# PARKER AND PINE FILING NO. 1 LOT 2 – SITE PLAN

MURPHY OIL USA, INC.

COVER SHEET  
 MURPHY EXPRESS  
 12405 SOUTH PARKER ROAD  
 PARKER  
 COLORADO

HORIZONTAL CONTROL PLAN  
 MURPHY EXPRESS  
 12405 SOUTH PARKER ROAD  
 PARKER, COLORADO

SHEET NO.  
**A1.1**

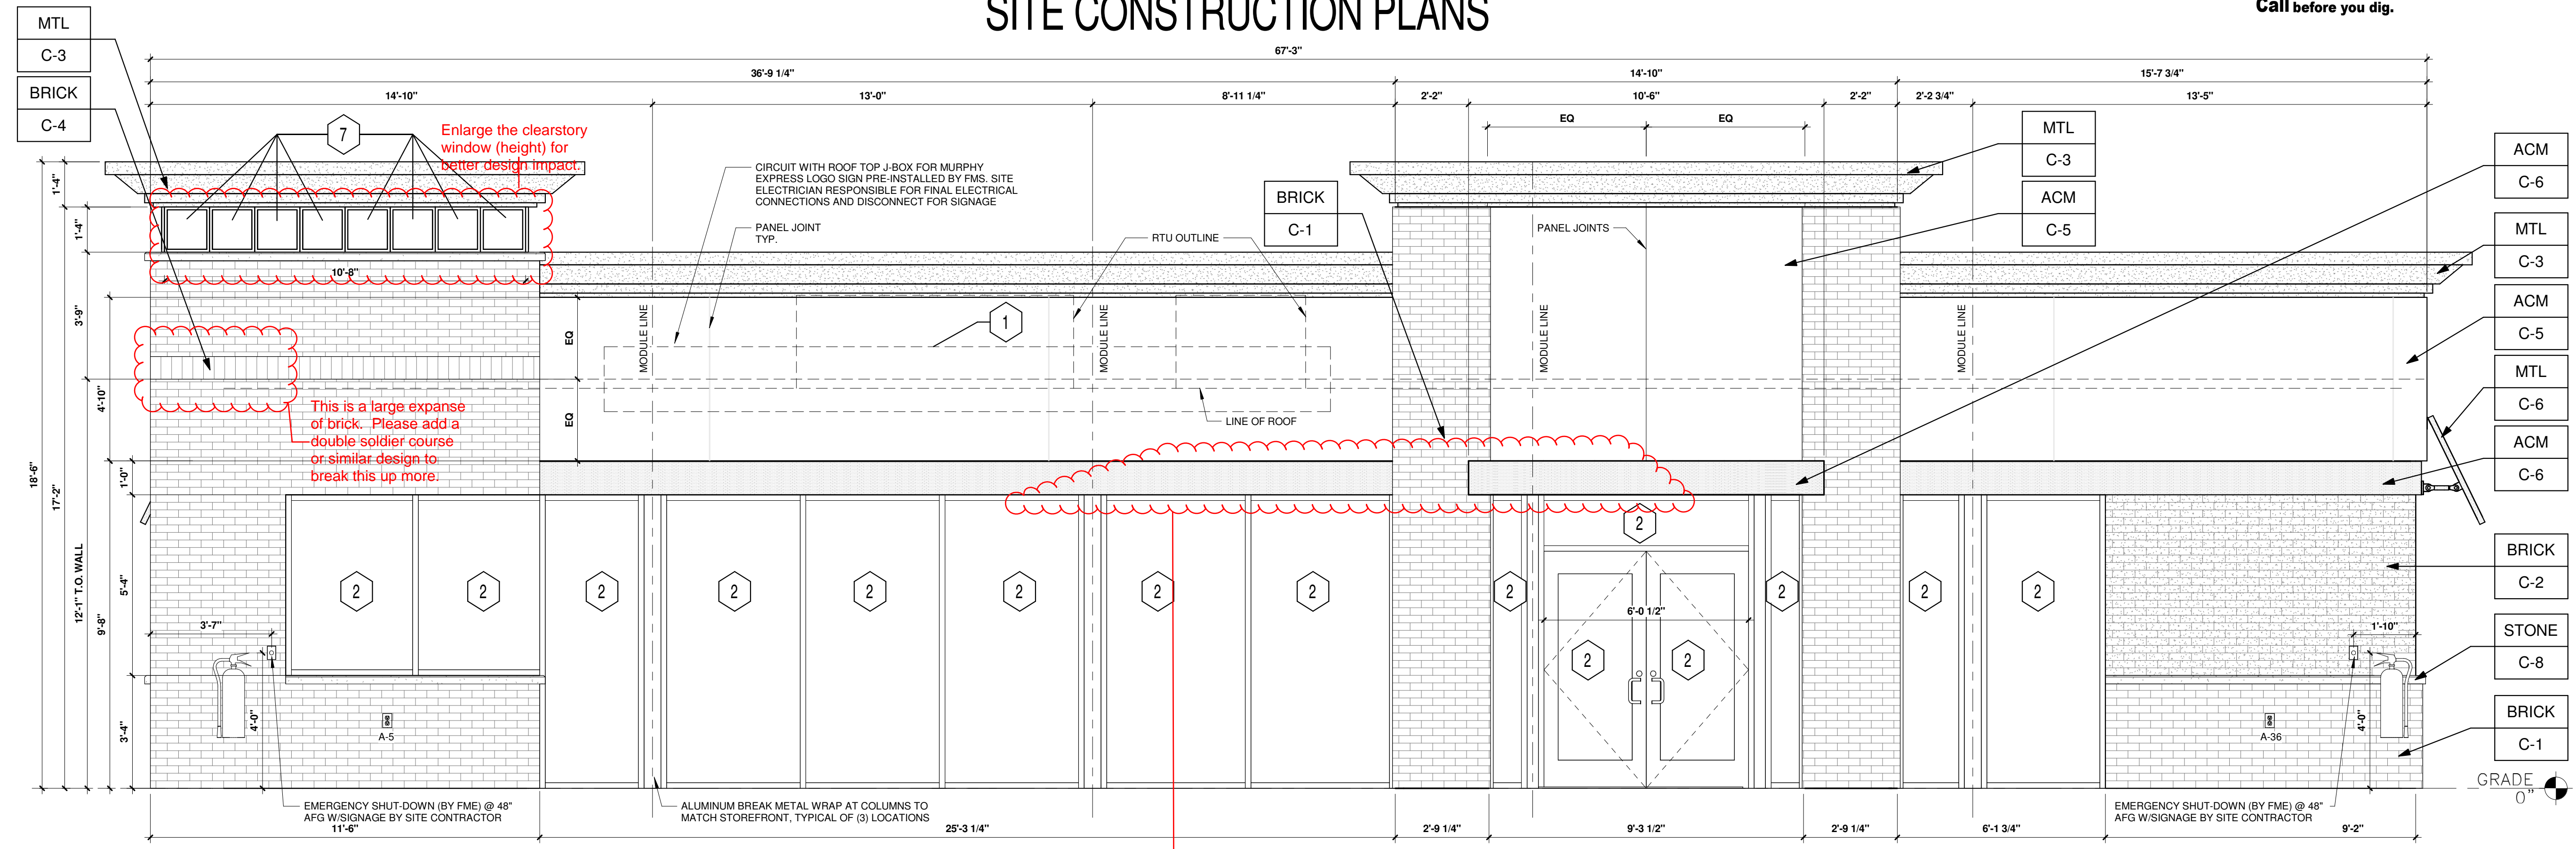
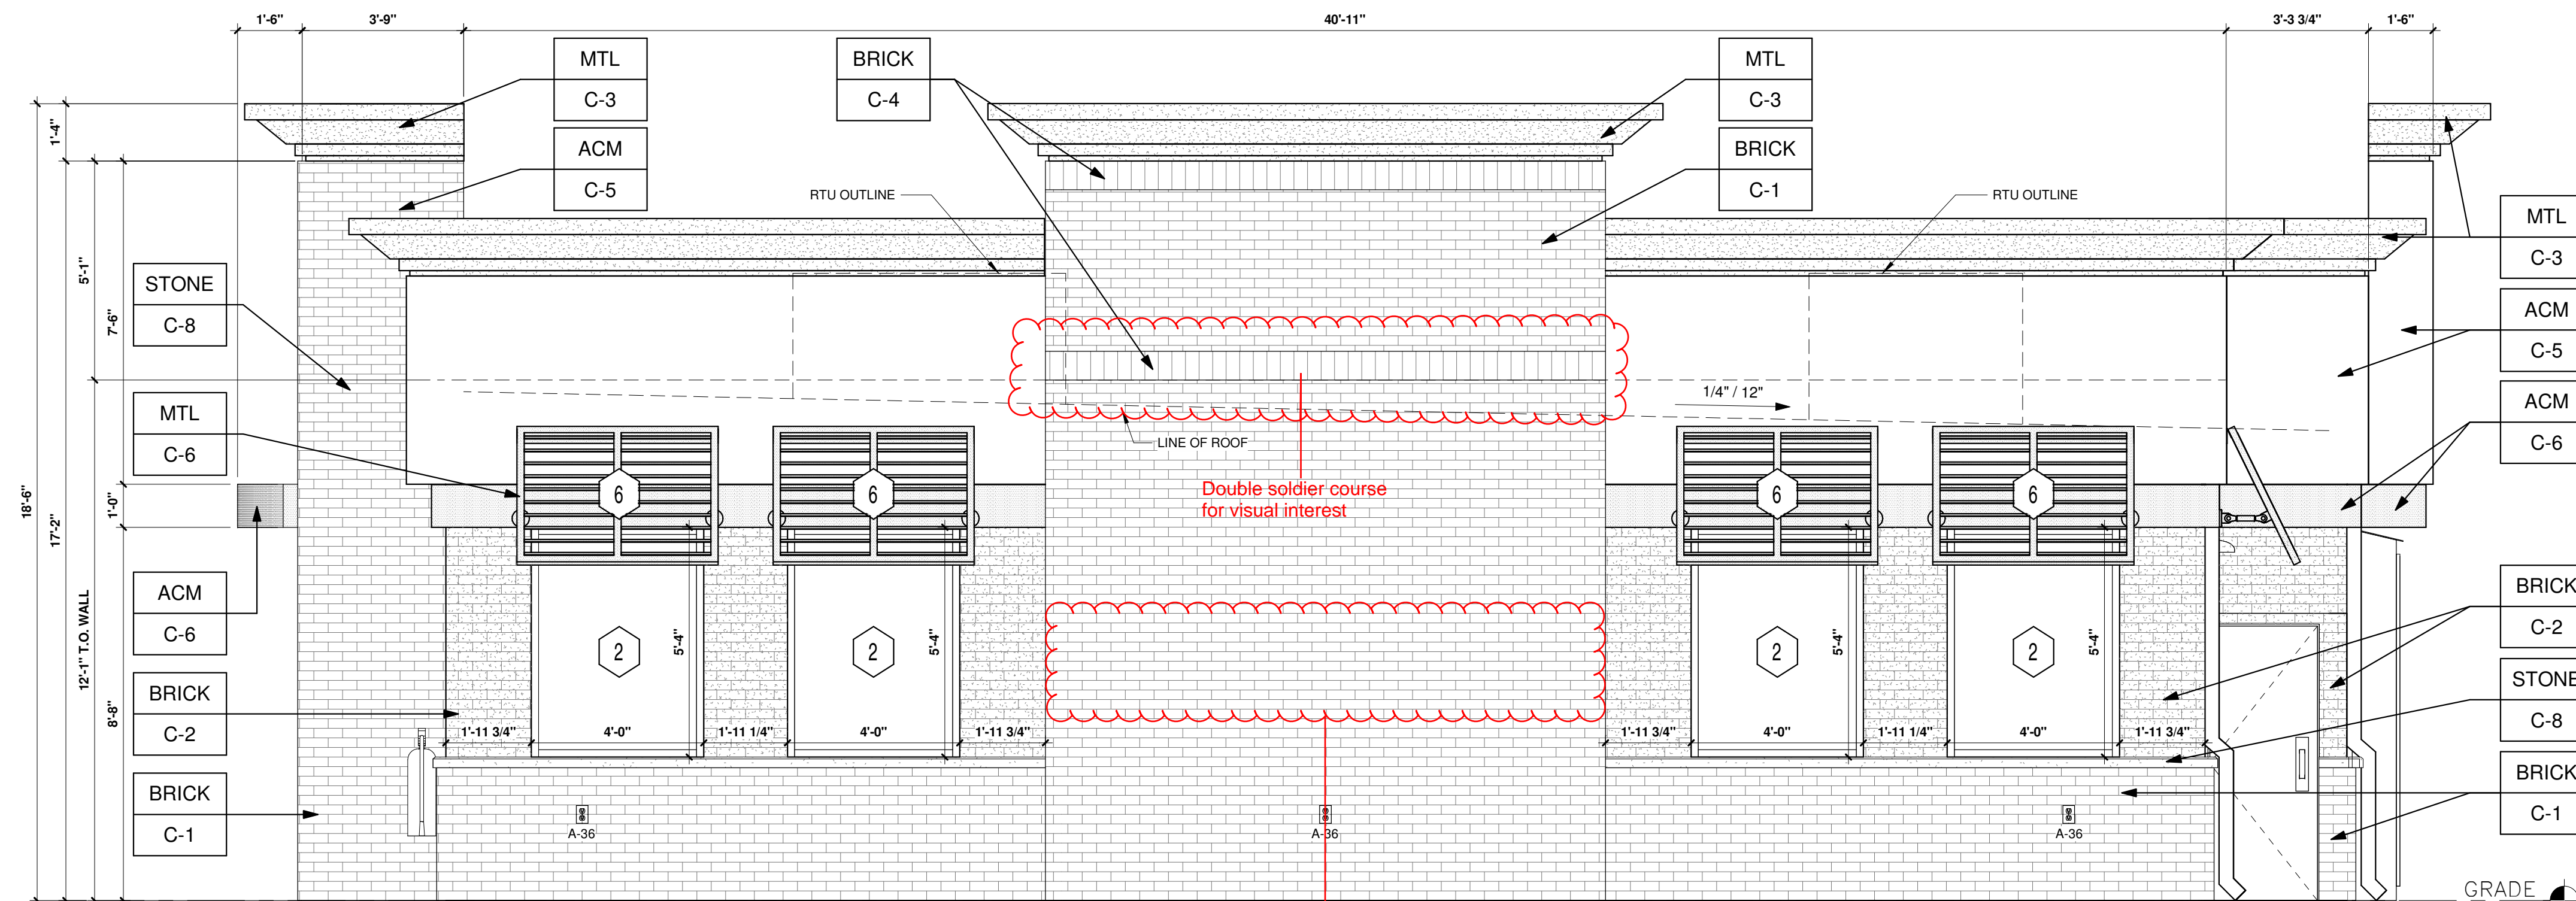
Sorry if I missed it, but what is the dimension of this overhang? Recommend slightly larger overhang than the 'typical' for architectural detail/interest.

Add additional double soldier course to break up this expanse of brick

SHEET NO.  
**A1.3**

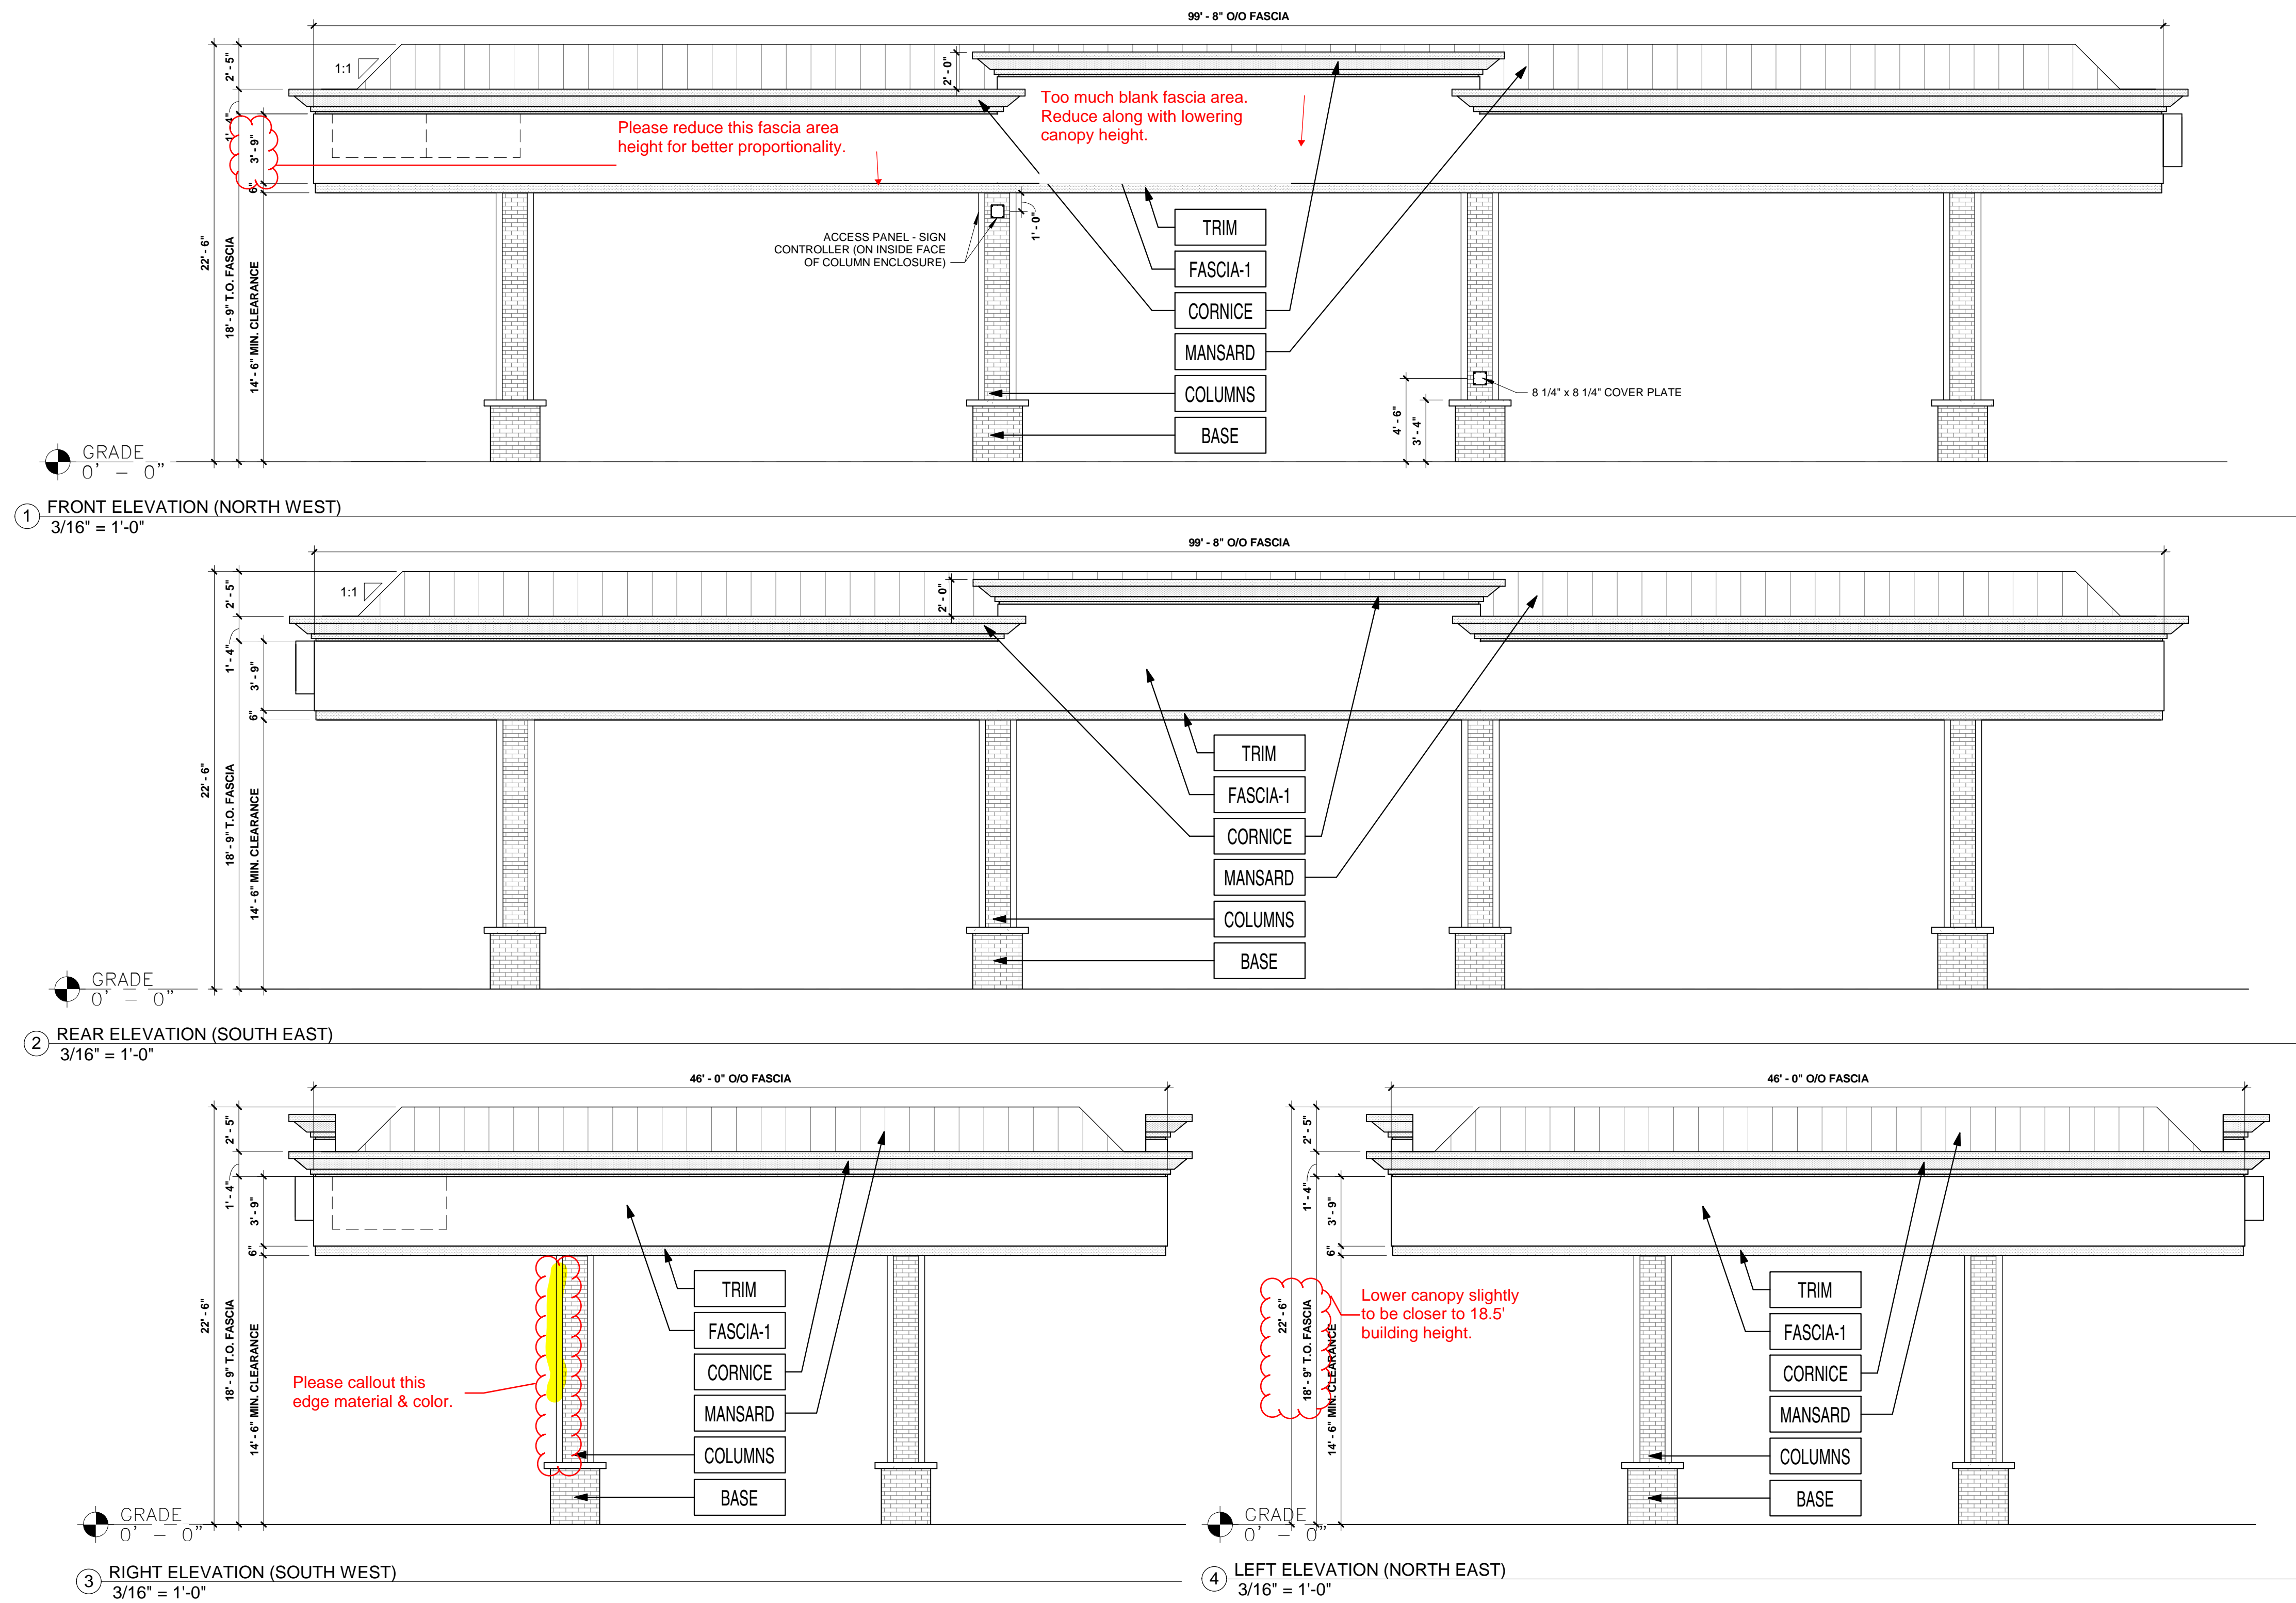
Roof sample required with material board & not provided. Please provide.

Too much blank fascia. See comment sheet A1.3. Revise color to meet PD allowed colors such as grey or black. This comment also applies to the C-store building.

Revise to an approved/allowed PD color such as grey or black

Please provide views of the roof and show all rooftop mechanicals, their screening (parapet detail) & their dimensions.

Revise color to PD approved charcoal/black or grey on all window trellis canopies.

Add double soldier course to break up this expanse of brick wall

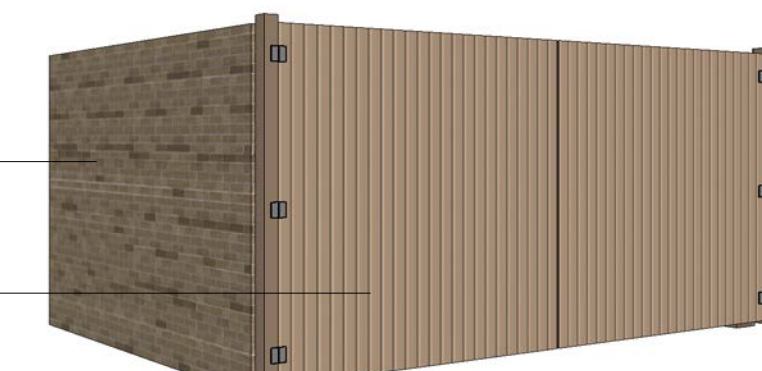
1. Large expanse of brick. Please add a double soldier course or similar to break it up.

2. Brick sample provided 11.18.20 is a darker solid (dark sand) color and does not resemble the color renderings. The brick sample is not a full size brick veneer & therefore staff cannot discern if the brown brick provided is naturally variegated in color as depicted in the renderings. Please clarify & revise renderings accordingly.

3. Colors and materials do not meet the standards of the Parker & Pine PD Guide. Please revise to meet the colors and materials below. New material/color samples will be required for review.

Please revise front entrance canopy with a more current look using prescribed PD colors charcoal/black or gray (example pic shown).

See comment 3 on this page & example pic to the right. Revise all fascia on this building with a more current/modern material such as the PD 'two-tone' wood panels or metal panel system that provides texture & visual interest - and aligns with the PD Guide.

1. Previous conversations with this application stated some limited use of corporate colors would be allowed as accent colors, however, the use of red is overused in this application. Please revise the gas canopy with the approved PD allowed colors using the red as the accent color on the small band. The larger band color needs to be an approved PD color.
2. Metal awnings over windows should be the PD color (charcoal or grey). Please revise color of the metal awnings.
3. ACM Fascia: please revise this material to PD required materials such as the 'two-tone wood looking siding'

EXAMPLE: Use similar grey metal panel system in lieu of proposed low quality sheet metal which has no texture or visual interest. Pergola canopies at public entrances to match.

### 7 MONUMENT SIGN

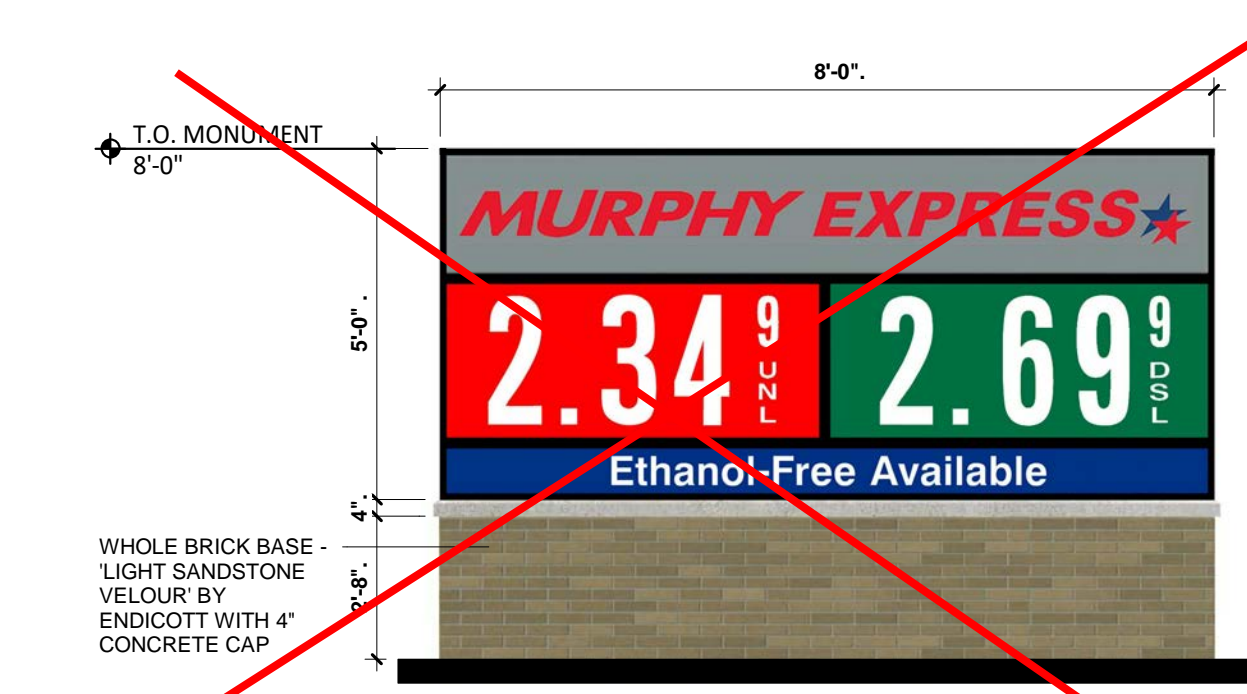
Signs processed via a separate Sign Permit application. Please remove from site plan set.
